Docket Item #17

Development Special Use Permit #2007-0031
PNC BankPlanning Commission Meeting
September 4, 2008

ISSUE: Consideration of a request for a development special use permit, with site plan, to construct a bank facility with drive-thru service.

Figure 1: Site Plan

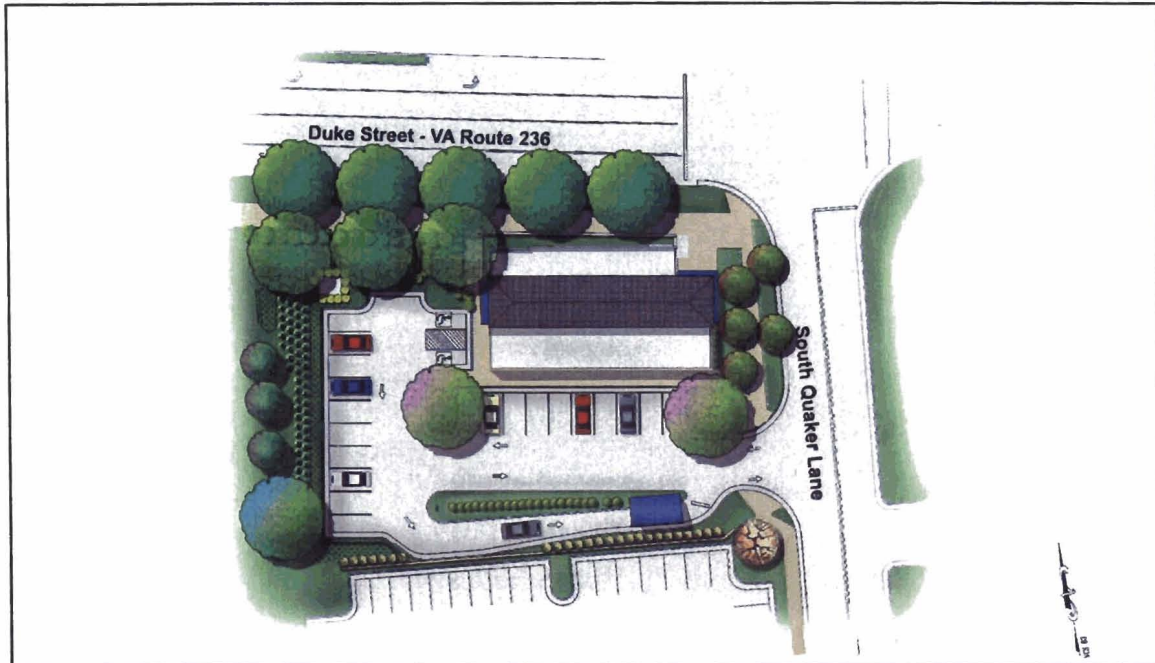
The building has been sited and designed to improve the orientation to the street by placing the building at the corner of the property nearest to the intersection of Duke Street and South Quaker Lane. Staff worked with the applicant to make changes to the original proposal which includes the following improvements:

- Increased window size on both North and South facades to break up what was otherwise fairly solid looking facades with windows that appeared too squat;
- Revised the East facade to reorient the door entry to the street intersection;
- Increased pedestrian access to the building from Duke Street by adding a walkway with steps to the West entry doors and create a small inviting plaza at the Northeast entrance; and
- Approved the type and use of quality building materials.

Staff has concerns with two parking spaces located at the southwest corner of the site. Their close proximity to the drive-thru queuing space could potentially create conflicts between vehicles accessing the spaces and vehicles queuing. Staff recommends designating the two spaces for employee parking to restrict who accesses the spaces and when, as well as to reduce potential conflicts.

15. A high-quality closed circuit TV (CCTV) system shall be installed to provide real-time or recorded surveillance of areas not immediately accessible to bank personnel. (Police)
16. The two parking spaces at the southwest corner of the site shall be designated for employee parking only. (T&ES)
